To: All Interested Bidders and Plan Holders
From: Jennifer Steed, Senior Project Manager
RE: Lake Myra County Park Phase 1 (RFB#26-077)
Addendum No. 4 – FINAL ADDENDUM
Date: September 30, 2026

TYPICAL BRIDGE
DETAILS

LAKE MYRA COUNTY PARK
Wake County, NC

BOARDWALK PLANS

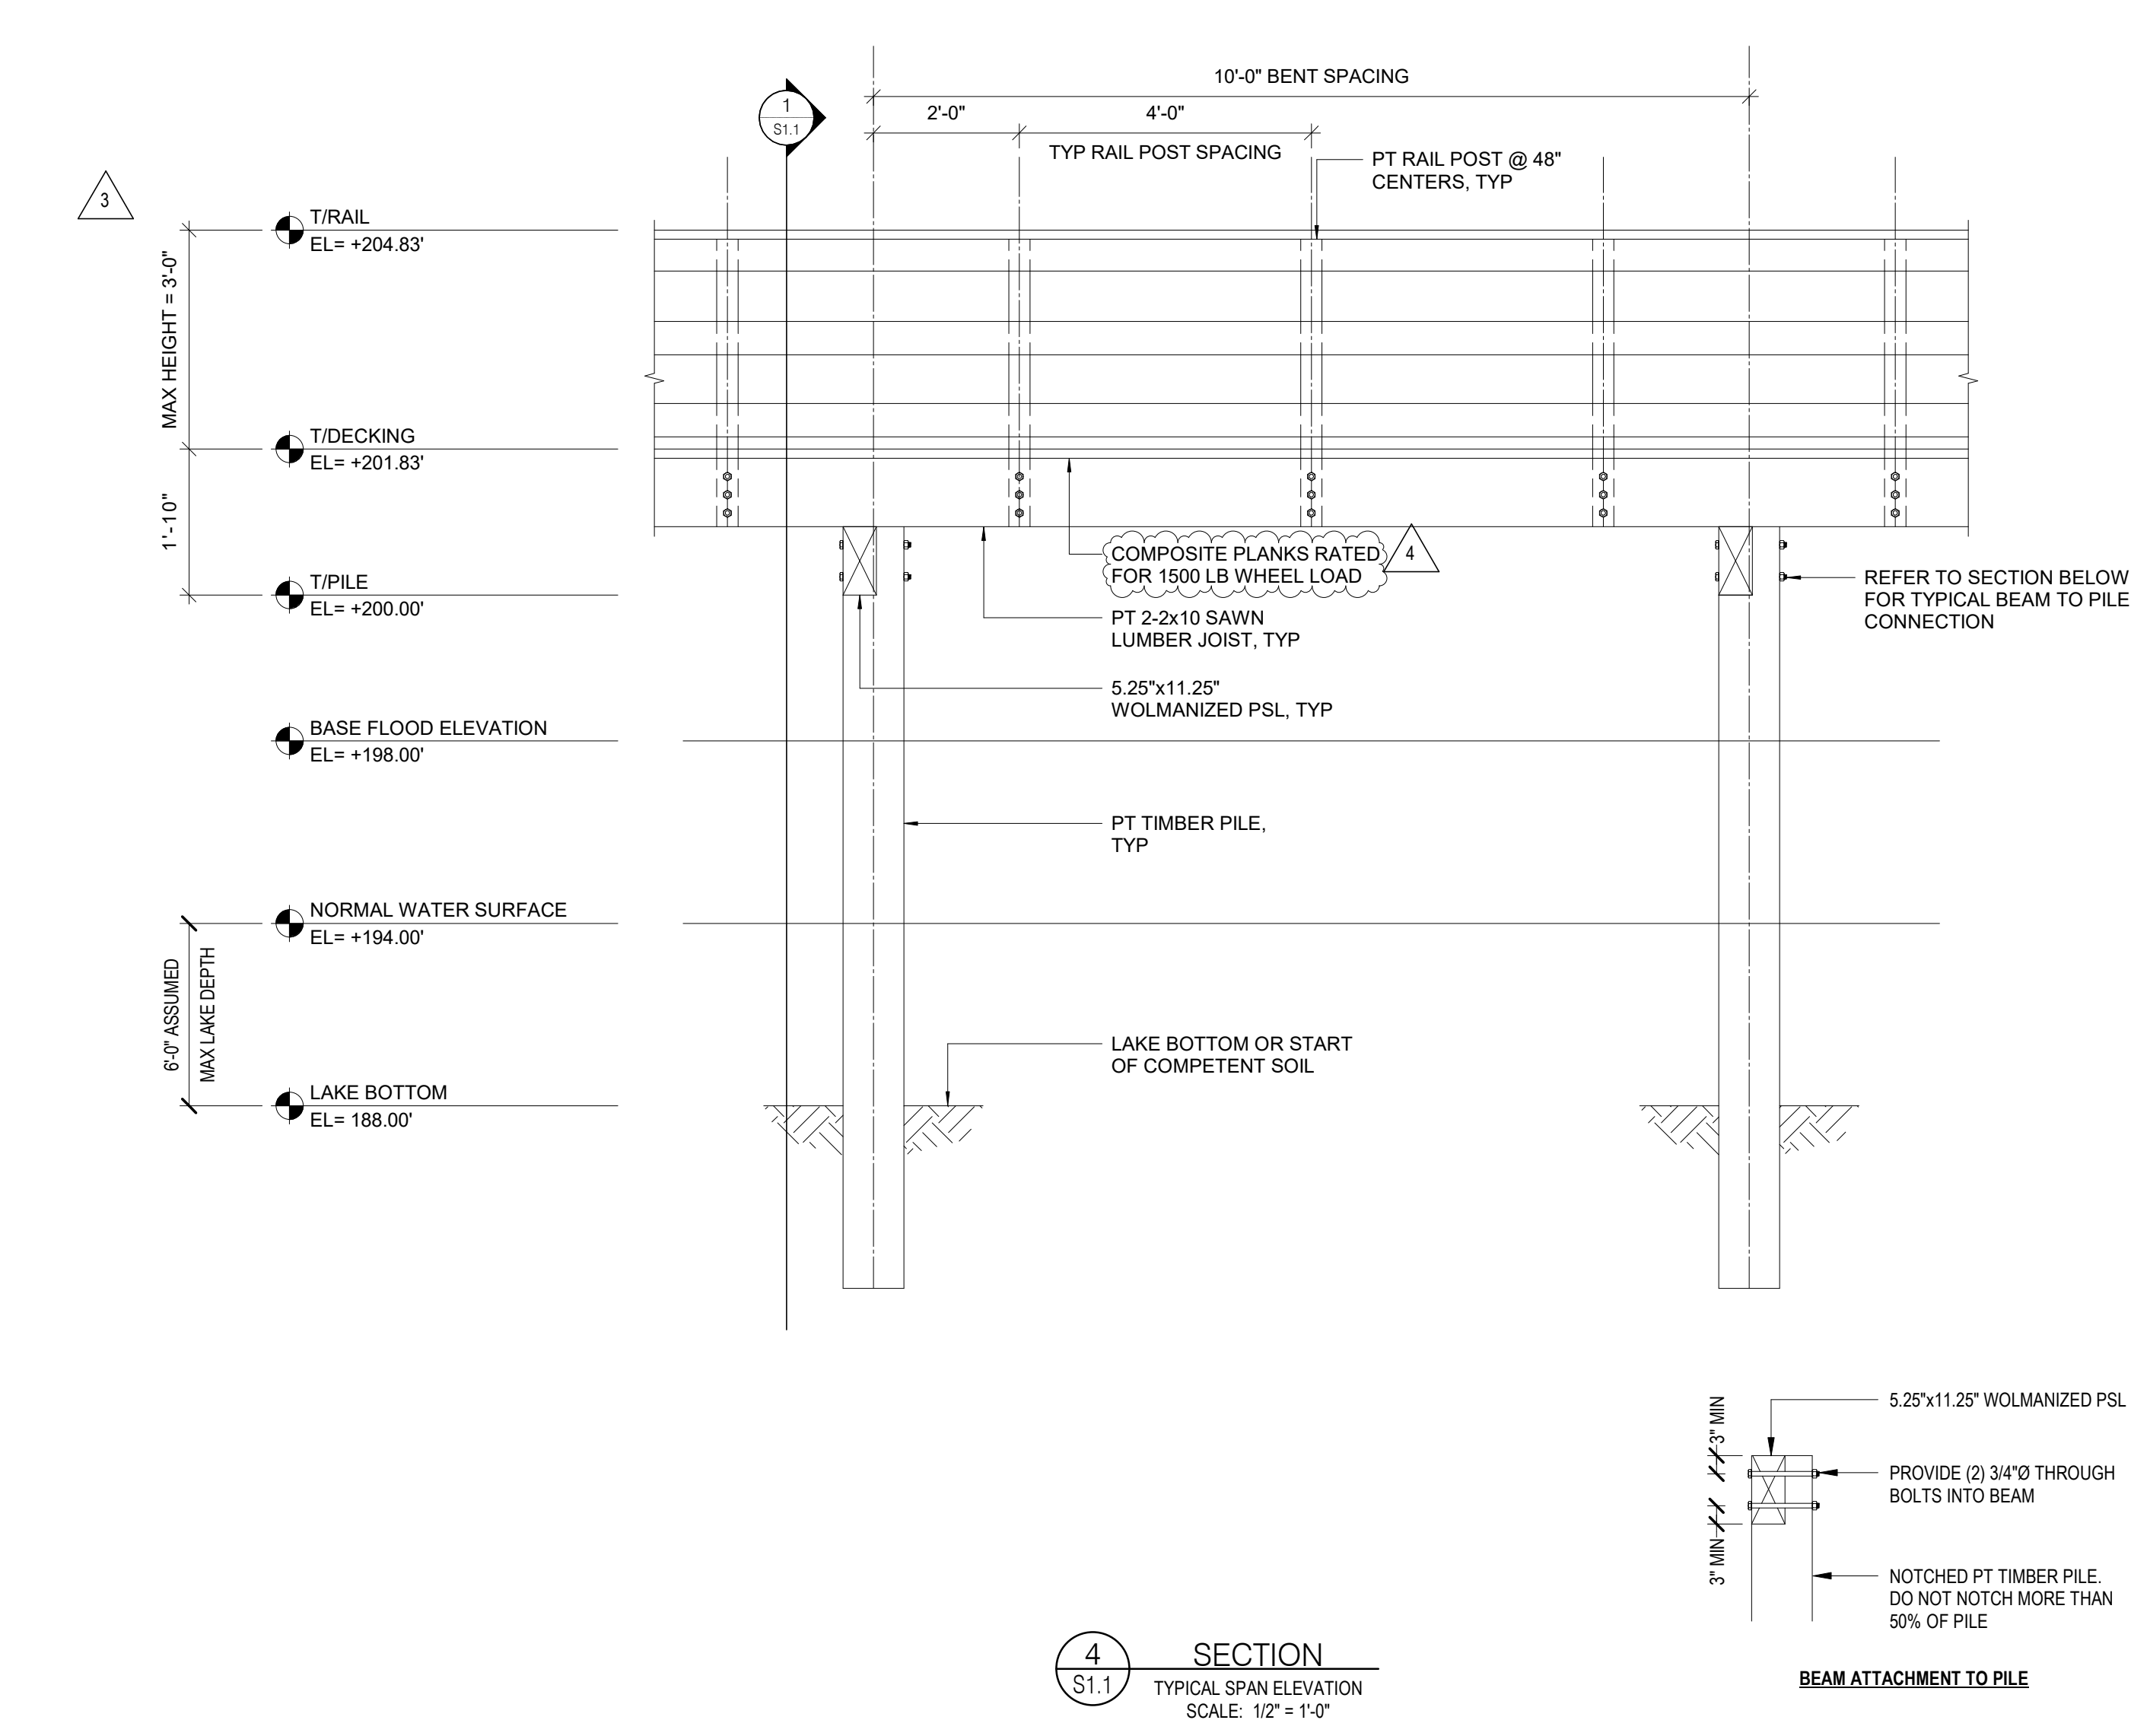
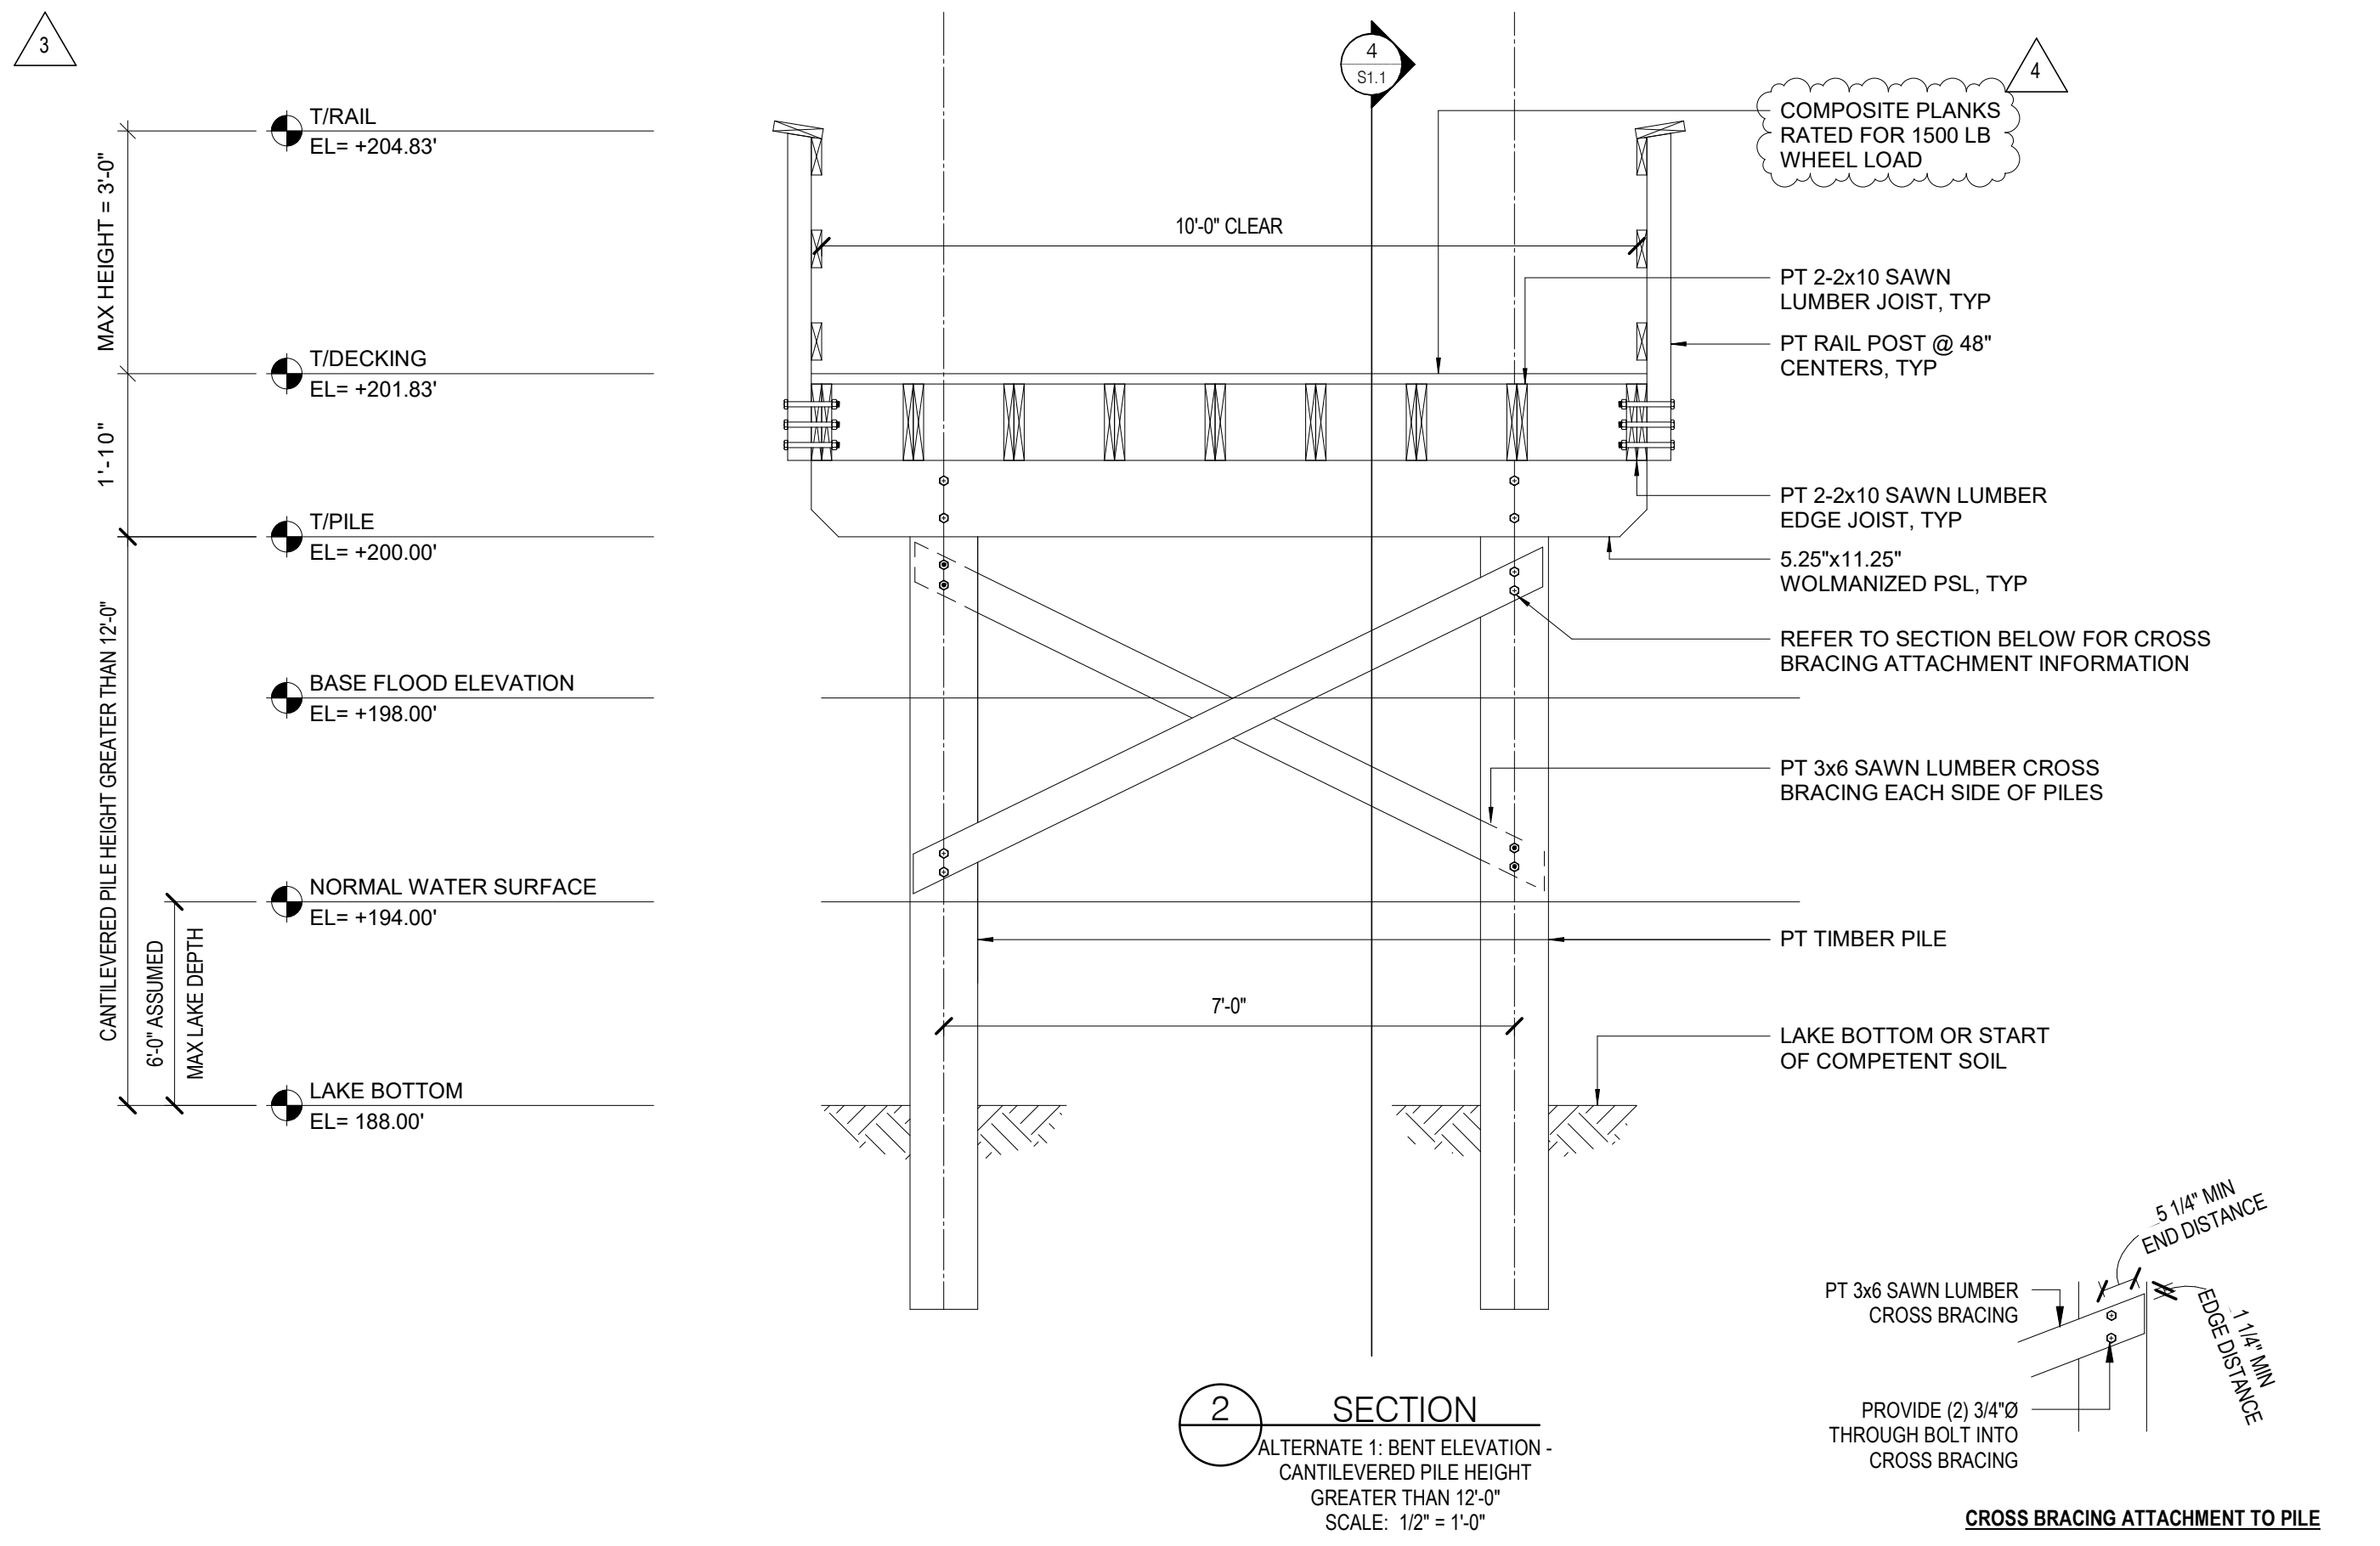
REVISIONS		
3	ADD COLUMN 3	9/20/2026
4	ADD COLUMN 4	9/20/2026
